Access Report

Bardo Living
36 Bardo Road
NEWPORT NSW

For: Popov Bass Architects
Ref: LP_22463

Development application documentation for the proposed seniors living development at 36 Bardo Road Newport has been reviewed against current and applicable accessibility legislation.

Figure 2 | Overall Site Plan

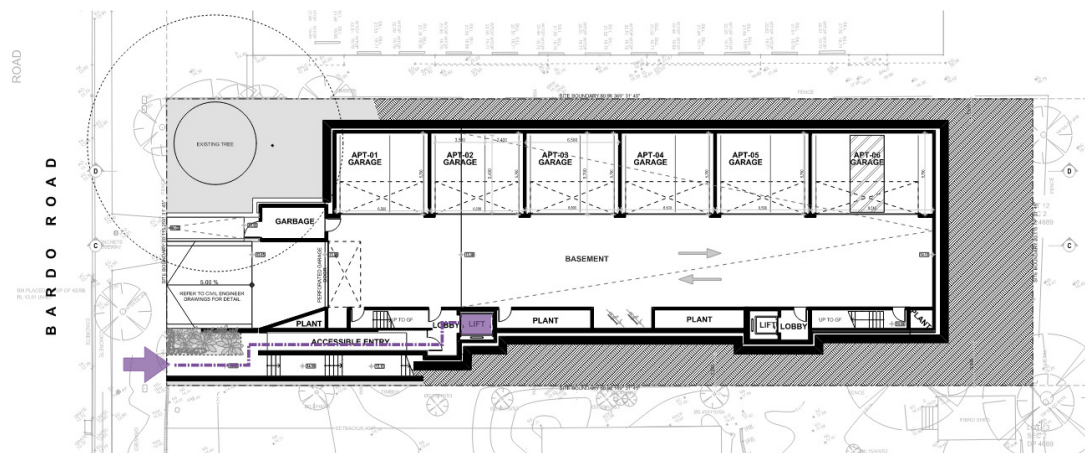
An accessible path of travel is provided to the building entrance from the allotment boundary along Hunter Street via pathways that are level.

Level access is available between the car parking and the lift at the basement level.

Accessways are a minimum 1200mm wide and provide a level surface. Adequate circulation areas are achievable at changes in direction.

Stairs are provided as a part of the pedestrian access from Bardo Road to the building entrance. The overall configuration is capable of compliance with current accessibility legislation.

Detailed design to include the provision of handrails with extension to both sides, tactile indicators top and bottom and contrasting non-slip nosing strips to stair treads.
